Service Note		
Product	Description:	Service note no.
TC1280	Modification for Error 57	705 10 03 04

This note concerns units with serial no. between 121032 and 121556.

Fig. 1: Modification for Error 57.

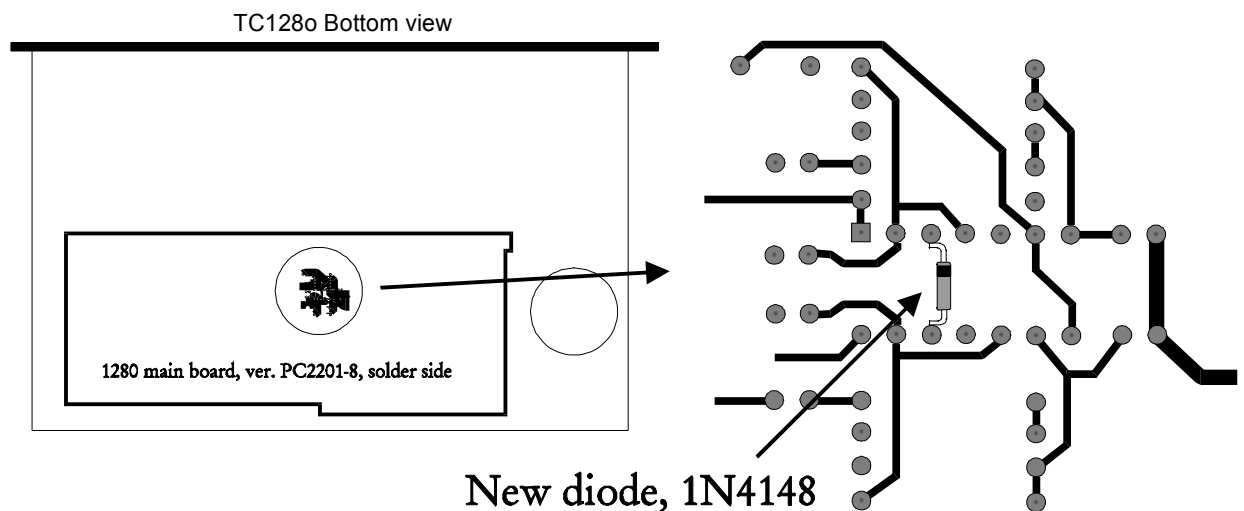
The TC1280 shows occasionally Error 57 at power on.

1. Turn Off Power And Disconnect Power Cord.
2. Dismount the bottom lid.
3. Solder in a new diode, type 1N4148, on solder side of the main board, see fig 1. The cathode is connected to IC301 pin 3 and the anode is connected to IC301 pin 12.
